**A57 Link Roads**

#### 9.72 Addendum to the Statement of Common Ground with High Peak Borough Council

<b>Rule Number:</b>	Rule 8(1)(k)
<b>Planning Inspectorate Scheme Reference</b>	TR010034
<b>Application Document Reference</b>	TR010034/EXAM/9.72
<b>Author:</b>	A57 Link Roads Project Team, National Highways and Atkins

**Figure 5.4 (Extract) - Air Quality Compliance Risk – A57 – High Peak Borough Council**

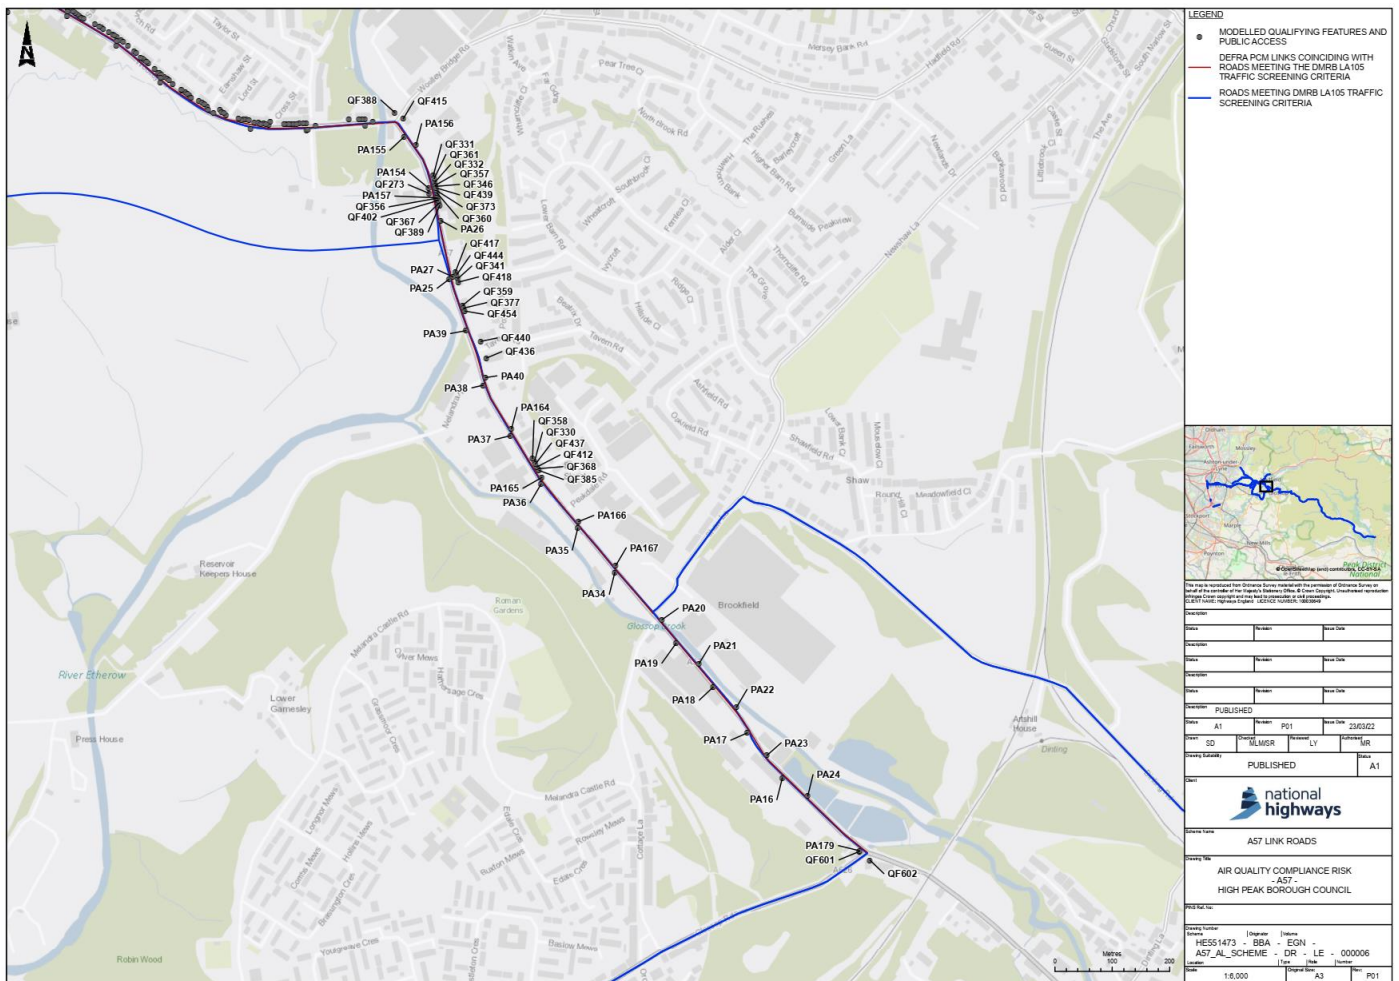
<b><u>Figure 5.4 Air Quality Compliance Risk Assessment – receptor labels</u></b>

HPBC Item	National Highways Position	HPBC Position	Status
<p><u>Item 8.38</u>            HPBC [REP4-011] asked for the A57 Brookfield qualifying features used in the NO2 compliance assessment to be labelled on ES Figure 5.4 [APP-080].</p>	<p>Given the number of qualifying features and public access receptors included in the compliance assessment it was not possible to practically label the qualifying features in ES Figure 5.4 (APP-080) however, an extract of ES Figure 5.4 zoomed in on the A57 Brookfield area with receptor ID labels for qualifying features and public access receptors adjacent to the A57 Brookfield is provided below this table.</p>	<p>Agreed  <u>Deadline 8 update (HPBC)</u>            It is noted that this response was supplied at deadline 7 by NH. Clarification of receptors did highlight that there were some relevant receptors in the Brookfield area that had not been included in general AQ assessment but had been included in the compliance assessment (see final row)</p>	<p>Closed</p>
